ADDENDUM NUMBER 1:
Route 1 South Utility Project
January 18, 2018

This Addendum forms part of the original document marked: **Route 1 South Utility Project.**

PROJECT: ROUTE 1 SOUTH UTILITY PROJECT
FALMOUTH, MAINE

6B

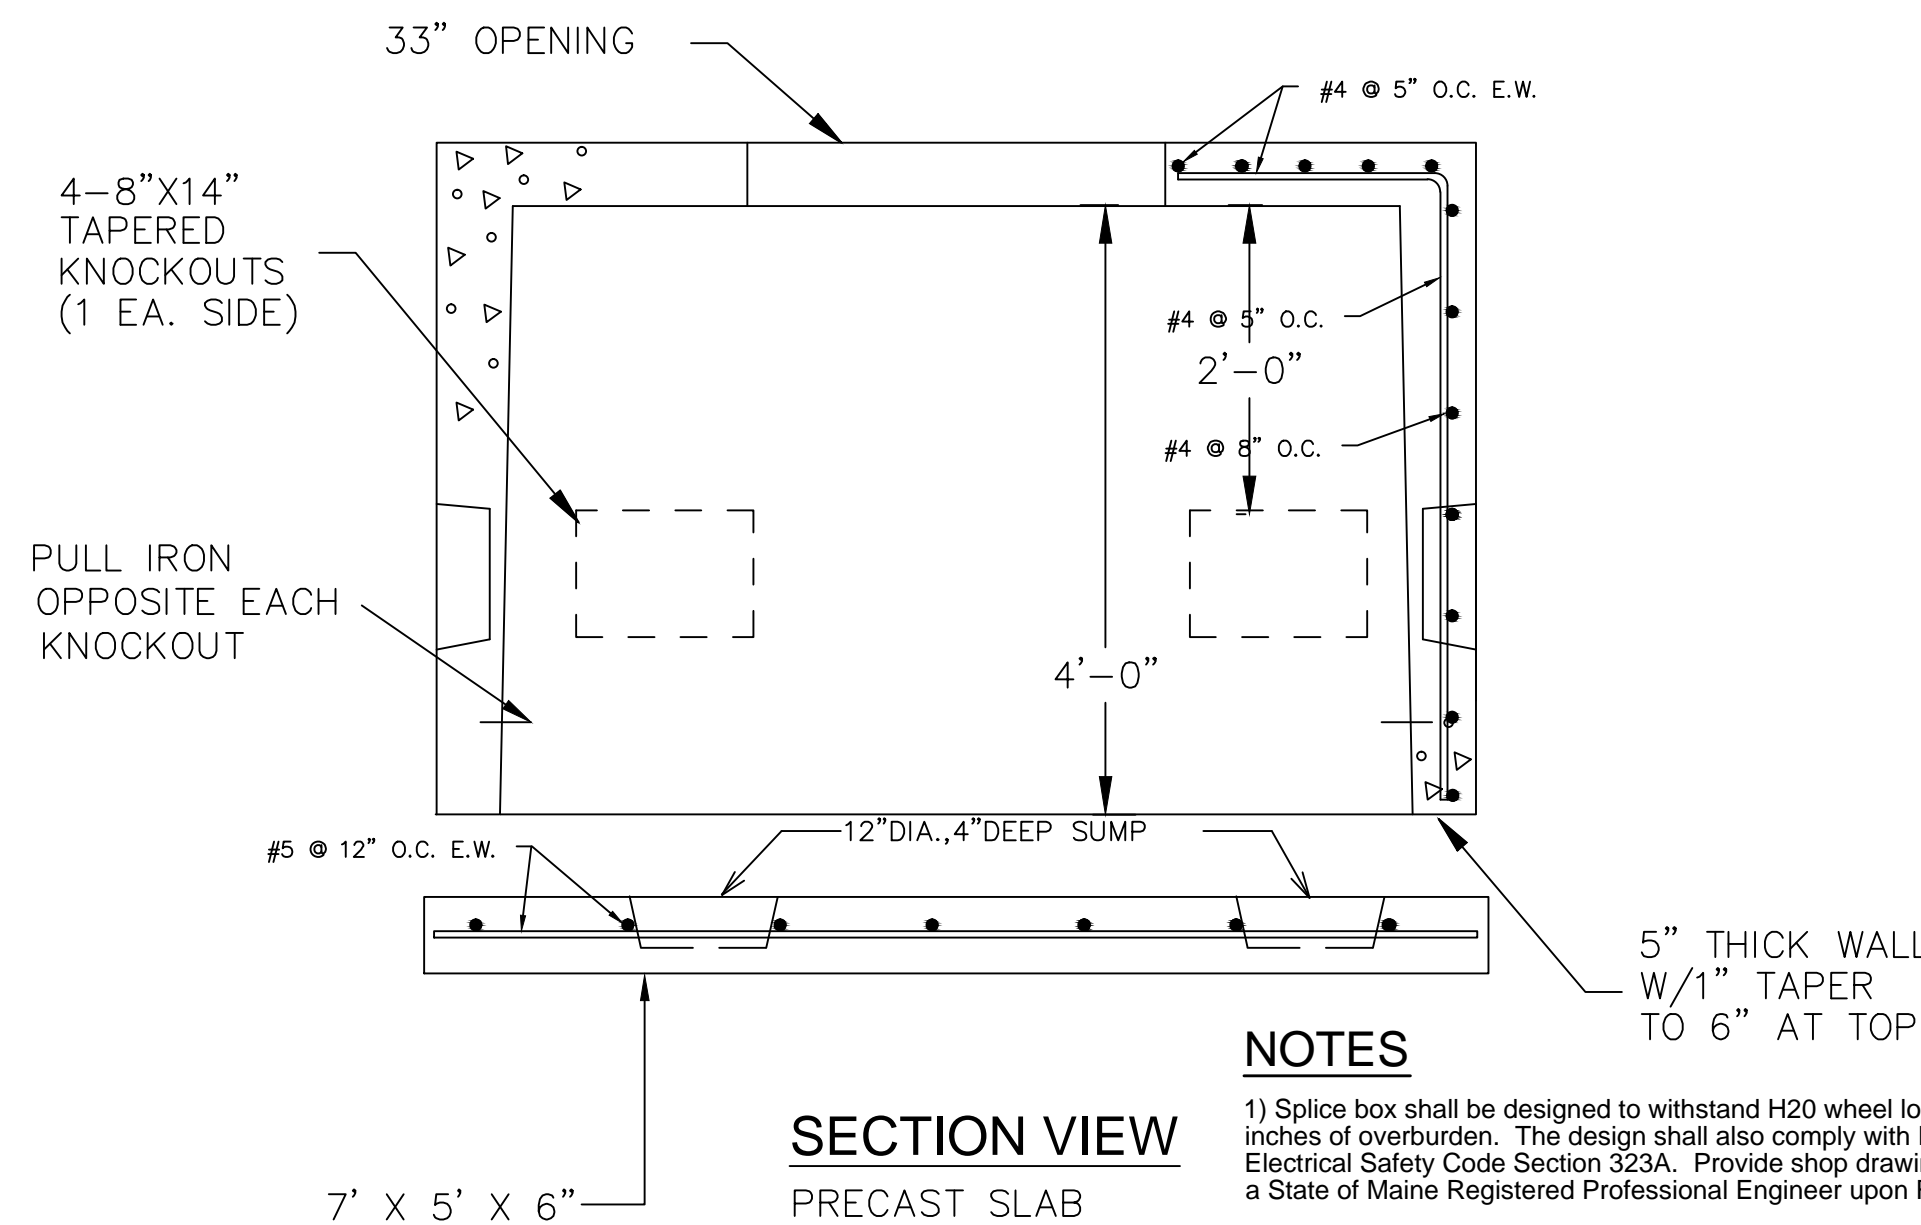
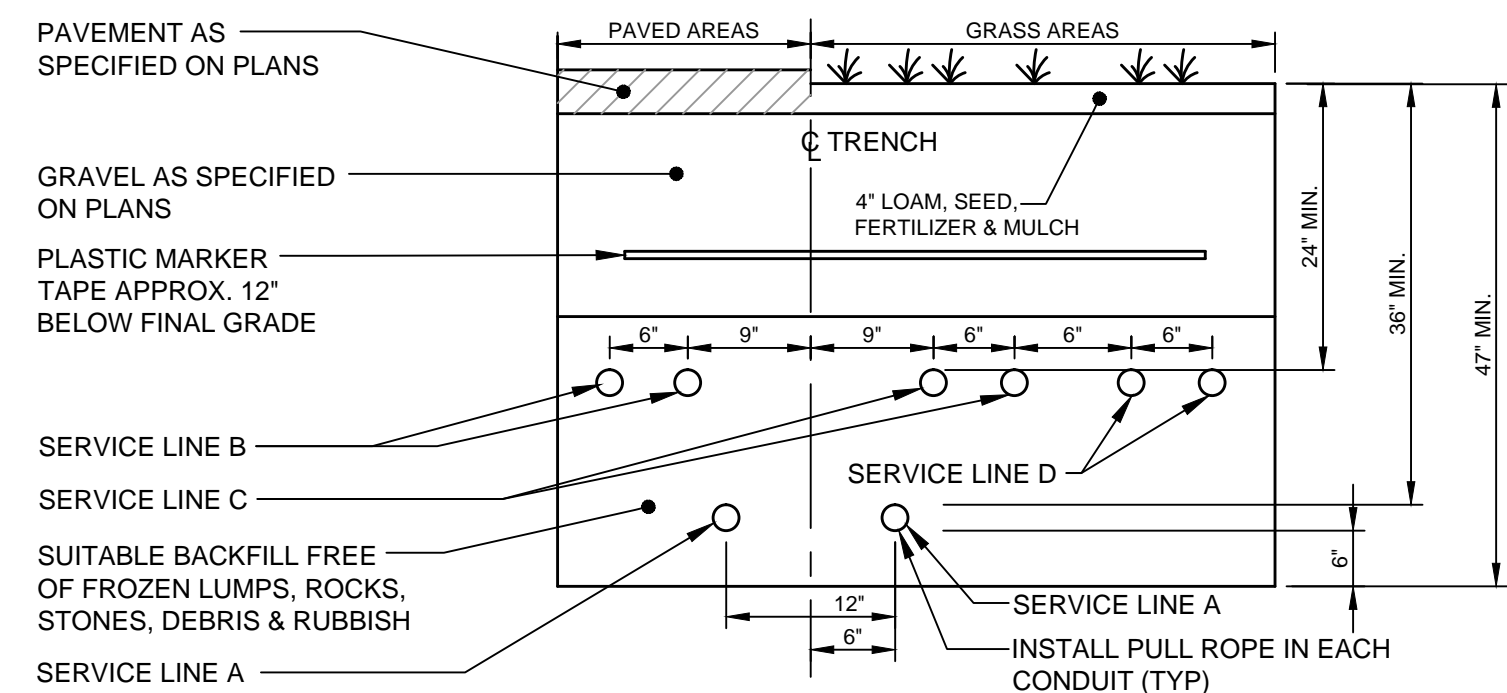
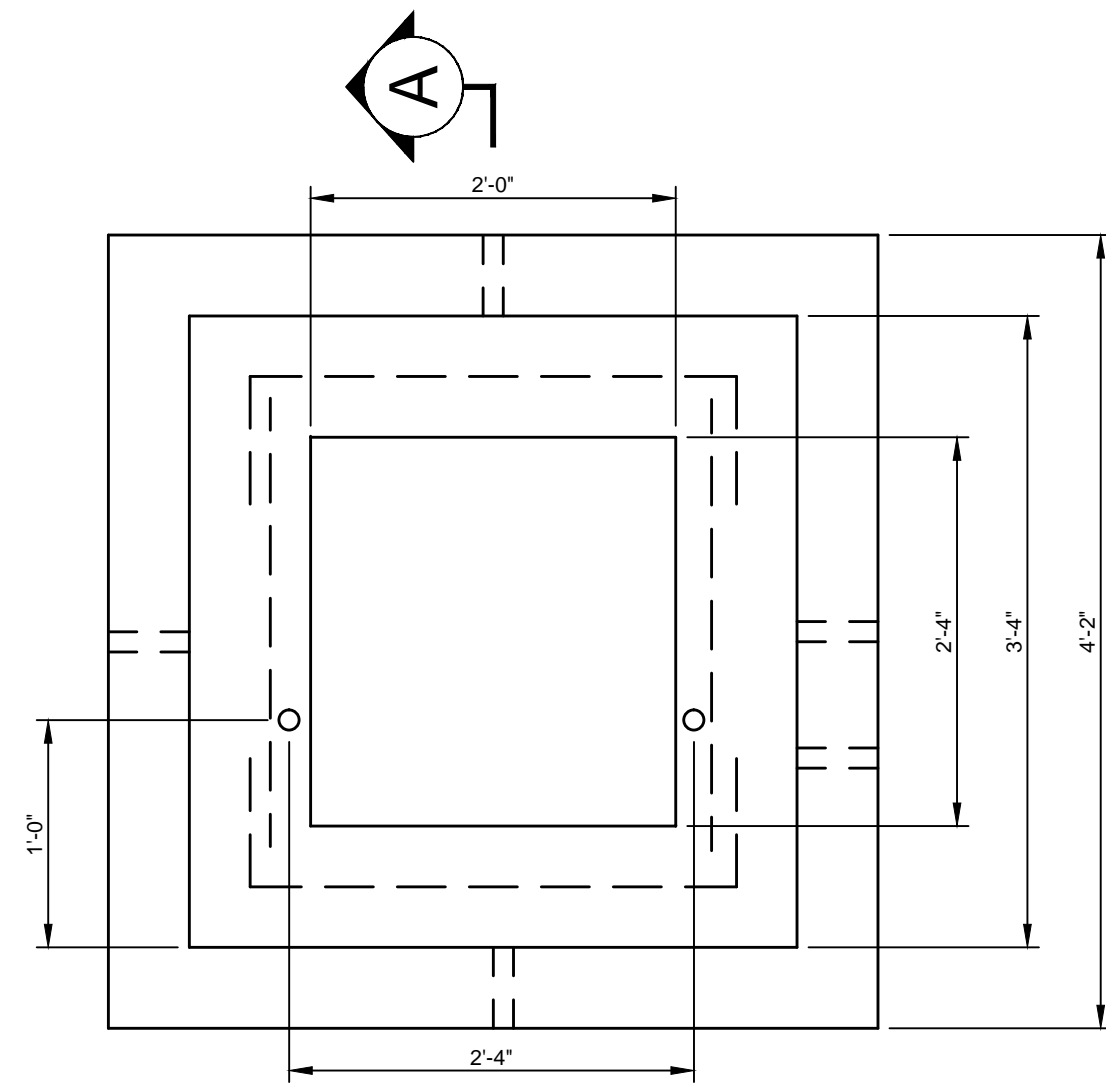
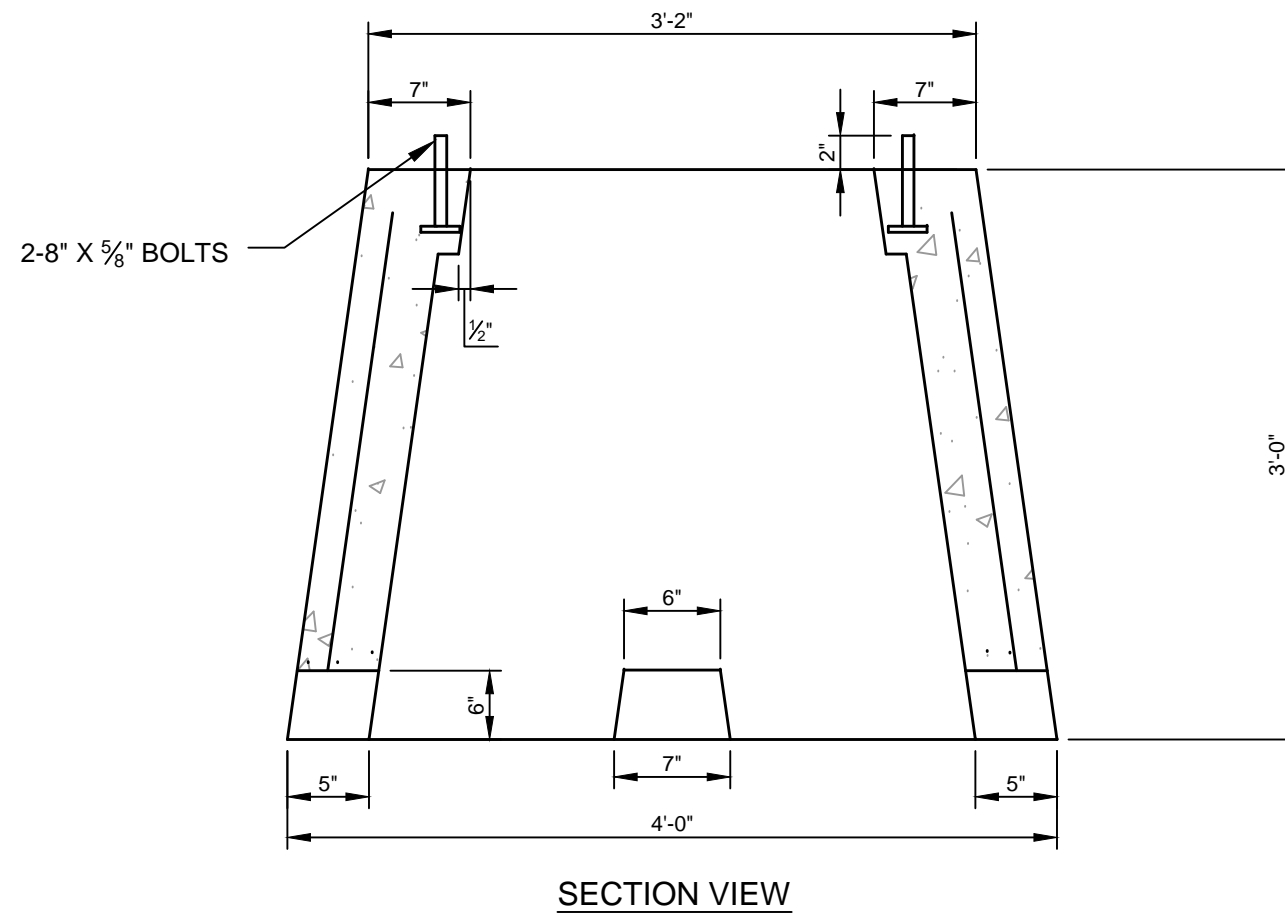
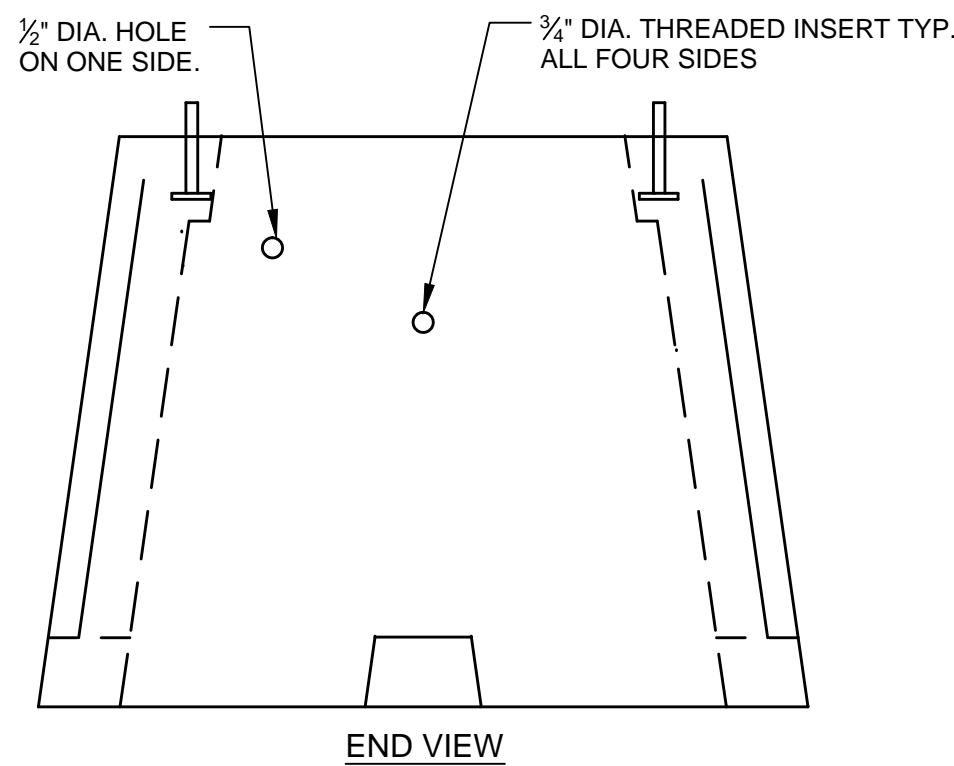
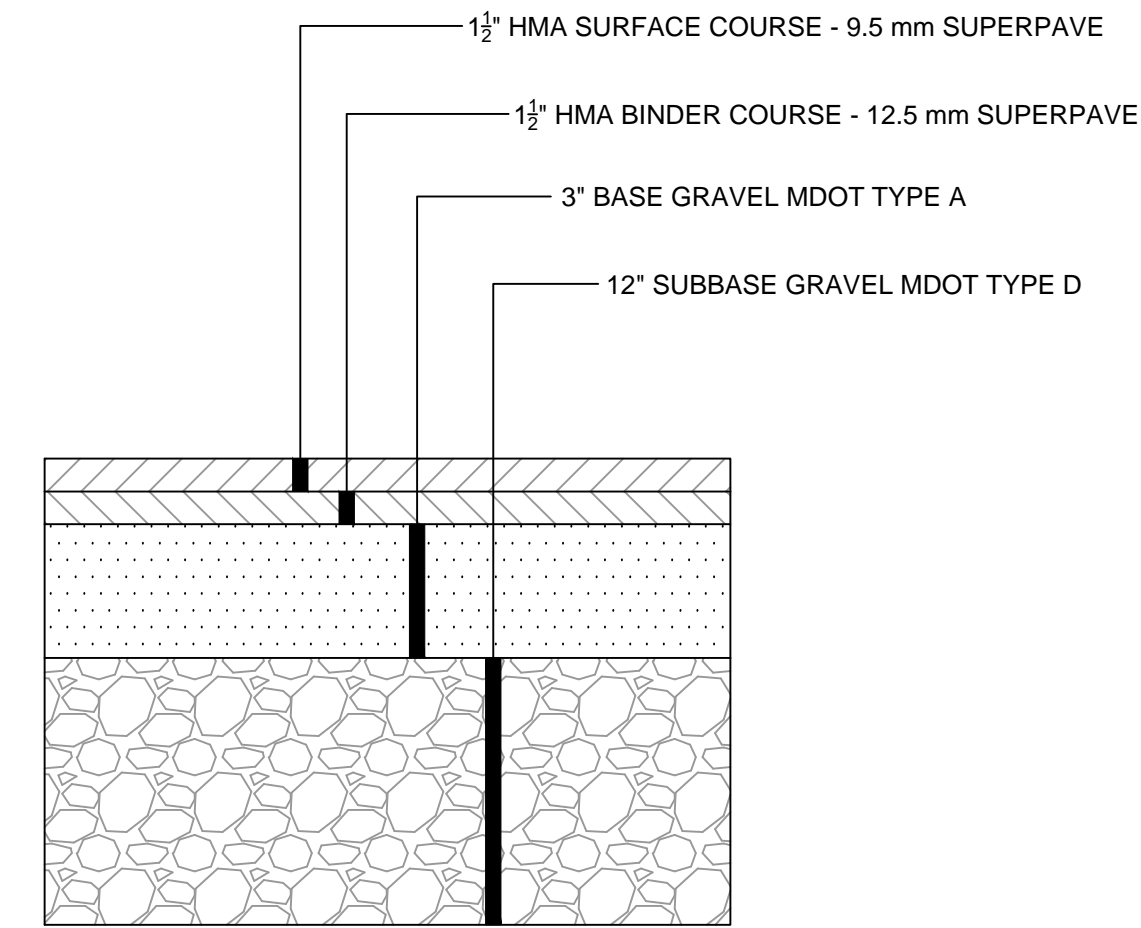
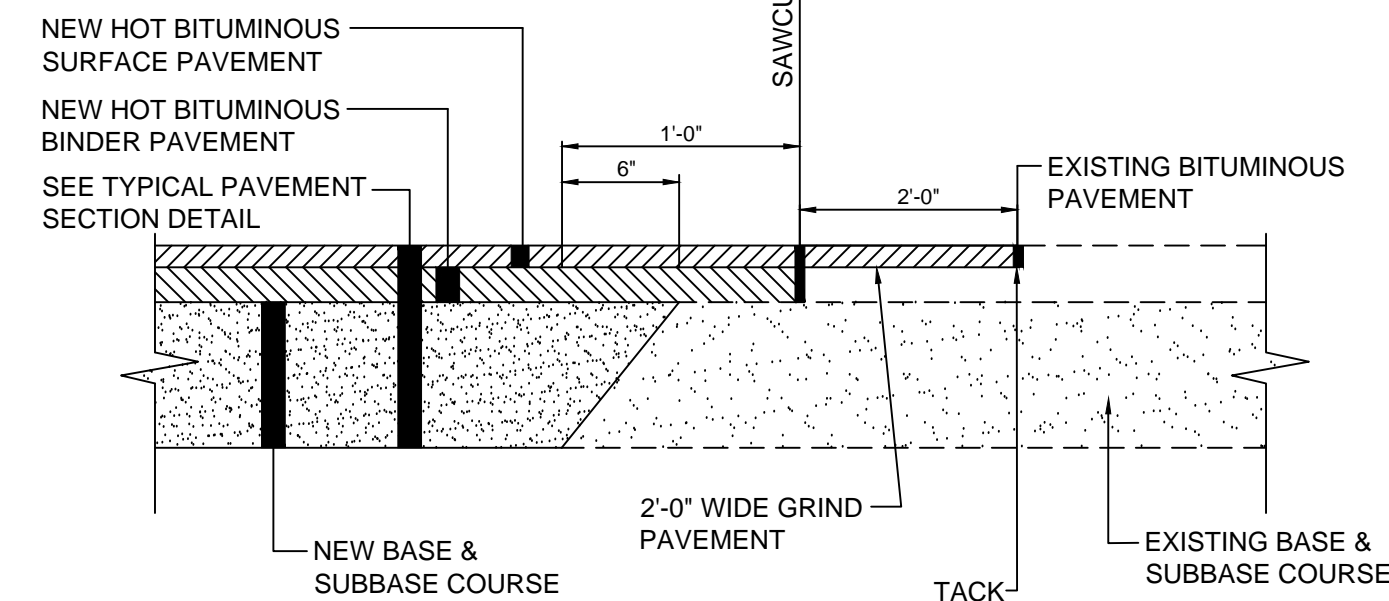
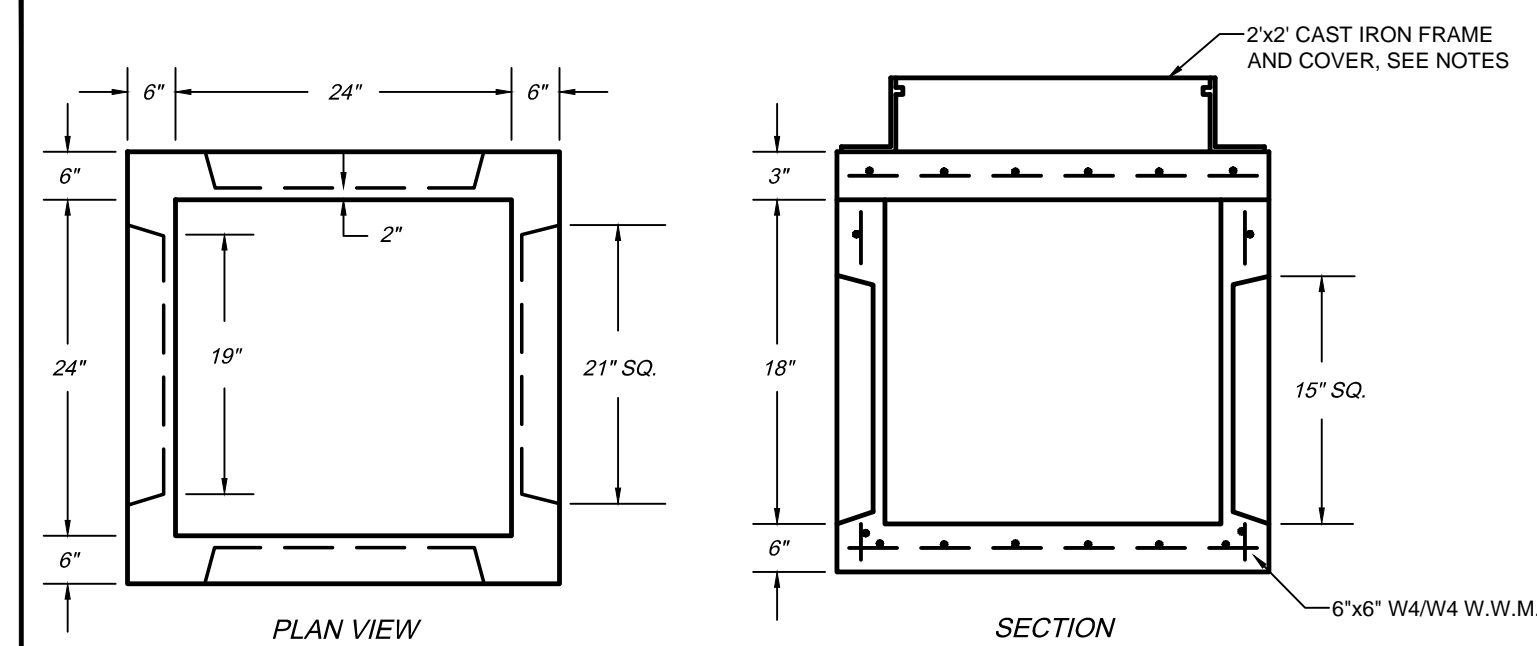
5). **ADD SHEETS 6A and 6B OF 6 (attached):**

Detail sheets 6A and 6B have been added to the set to include the following details:

- Pavement Restoration Section – Driveways and Non-Roadway Areas
- Pavement Sawcut Detail
- Single Phase Transformer Pad
- Utility Trench – Secondary Electric, Tel. & Comm.
- 4'x6' Splice box with 32" Round Cover
- Electric Duct Bank Details
- Duct Bank Details – Telephone, Cable TV, Communications, ETC.
- 24"x24"x18" Hand Hole Details
